CONSTRUCTION SUMMARY

397 - 2 - The Barossa 3 (38-3) Elev B

Extras at Time of Sale

Ground Floor

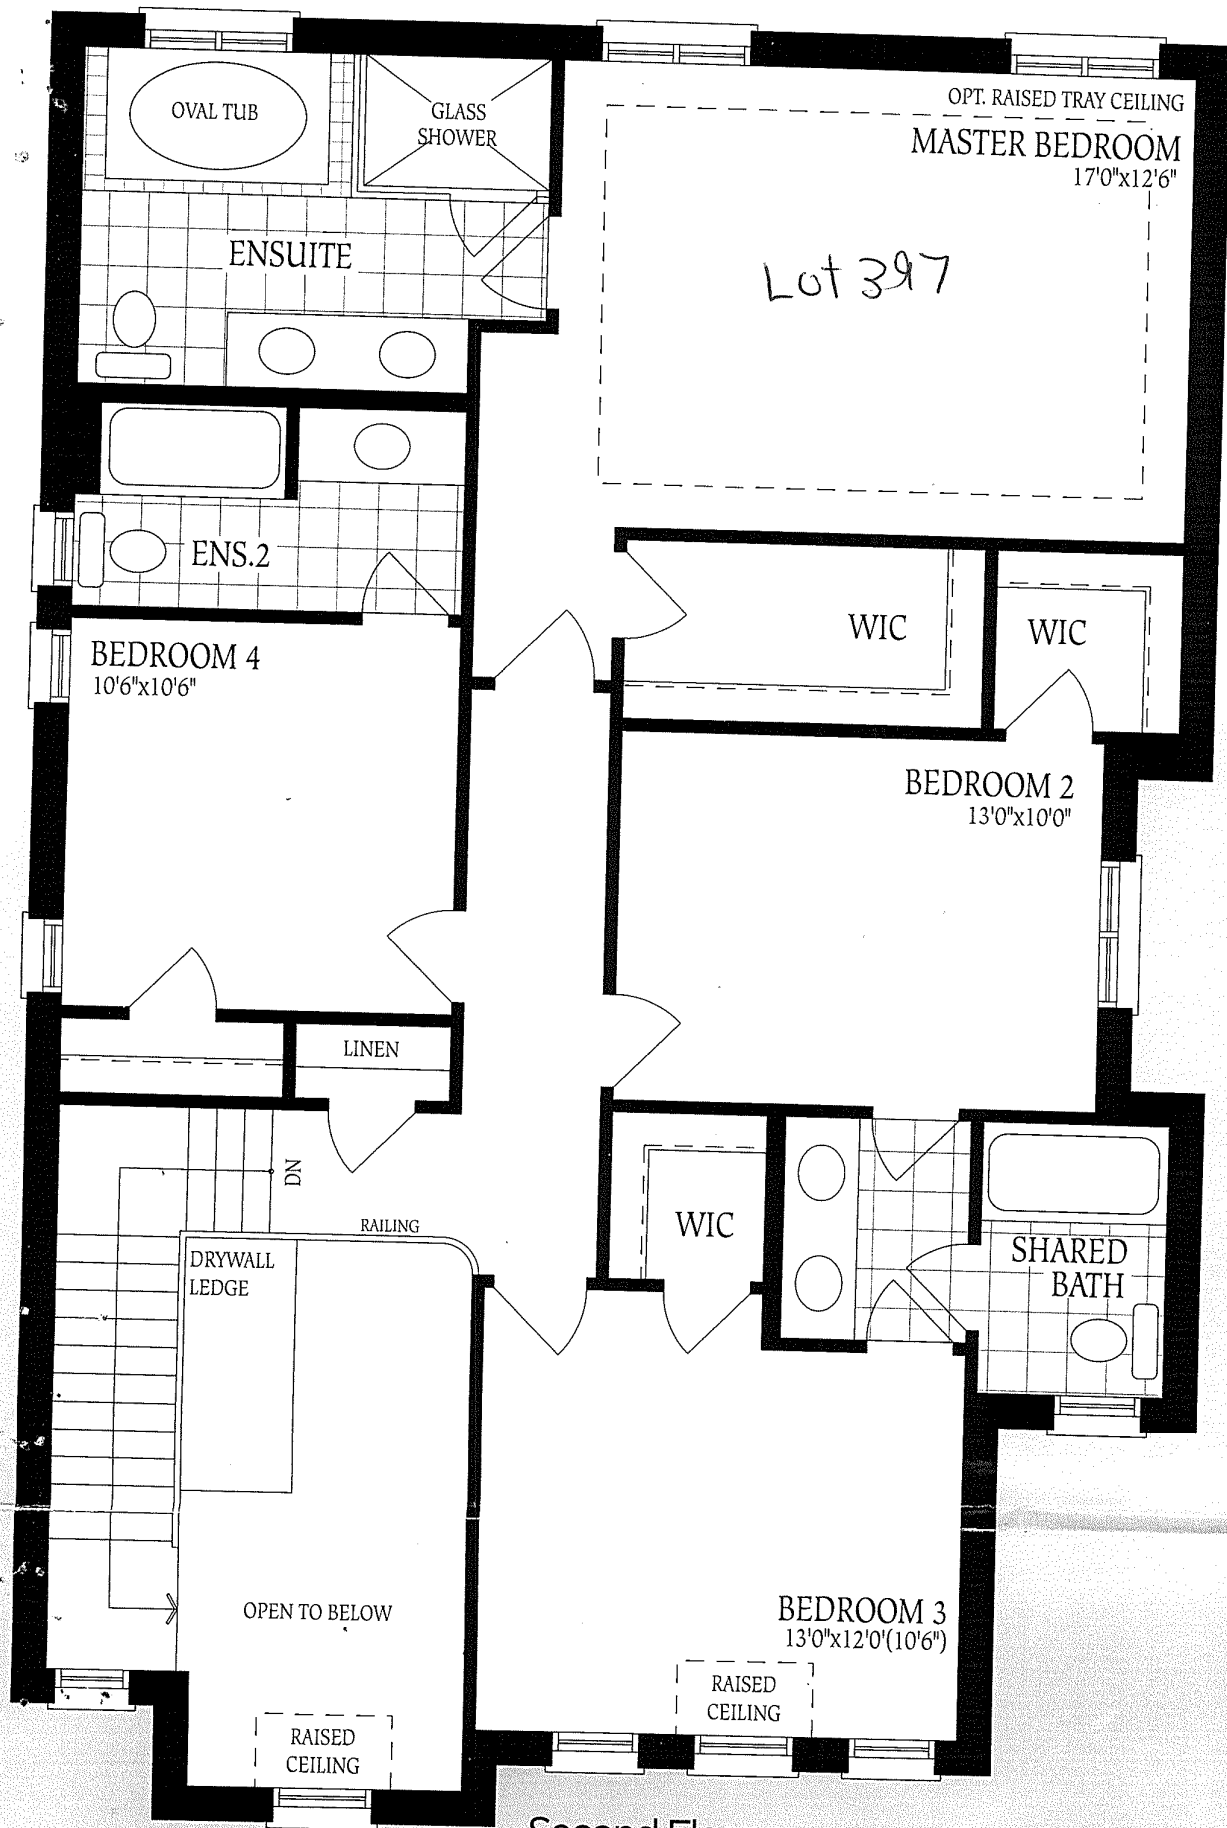
Inv.612	1 - ADD 3'-0" BASE AND UPPER CABINETRY IN KITCHEN AS PER SKETCH 3 X A01 3 X B01  PRICE QUOTED IS FOR STANDARD CABINETRY
Line5767	Note:
4Feb16 / 12May16

Inv.612	1 - DELETE WALL BETWEEN FAMILY ROOM AND KITCHEN
Line5765	Note:
4Feb16 / 12May16	
Inv.612	1 - CLOSE OFF WALL BETWEEN DINING ROOM AND KITCHEN
Line5766	Note:
4Feb16 / 12May16

Inv.612	1 - DIMMER SWITCH- FOR POT LIGHTS IN FAMILY ROOM
Line5755	Note:
4Feb16 / 12May16	
Inv.612	2 - VALANCE LIGHTING ROUGH-IN ELECTRICAL -AS PER SKETCH
Line5757	Note:
4Feb16 / 12May16	
Inv.612	8 - POT LIGHT - LED - 1ST FLOOR NON INSULATED CEILING - FAMILY ROOM - AS PER SKETCH

*****DO NOT INSTALL 2 POT LIGHTS AS PER SKETCH, THERE IS NOW ONLY 6 POT LIGHTS IN FAMILY ROOM IN TOTAL*****
Line5756	Note: USE SWITCH FROM EXISTING CEILING LIGHT THAT IS BEING DELETED
4Feb16 / 12May16	
Inv.612	1 - SWITCH - 2 WAY SWITCH FOR LIGHTING - FOR VALANCE LIGHTING ROUGH IN
Line5758	Note:
4Feb16 / 12May16	
Inv.612	1 - DELETE EXISITING CEILING LIGHT IN FAMILY ROOM - USE SWITCH FOR POT LIGHTS
Line5768	Note:
4Feb16 / 12May16	
Inv.723	1 - PLEASE LEAVE EXISTING CEILING LIGHT IN CENTER OF FAMILY ROOM - AS PER SKETCH
	PREVIOUS INVOICE #612 ITEM # 8 TO BE DISREGARDED
Line6770	Note:
21Apr16 / 12May16	
Inv.723	1 - SWITCH - 2 WAY SWITCH FOR LIGHTING - FOR POT LIGHTS IN FAMILY ROOM
Line6769	Note:
21Apr16 / 12May16
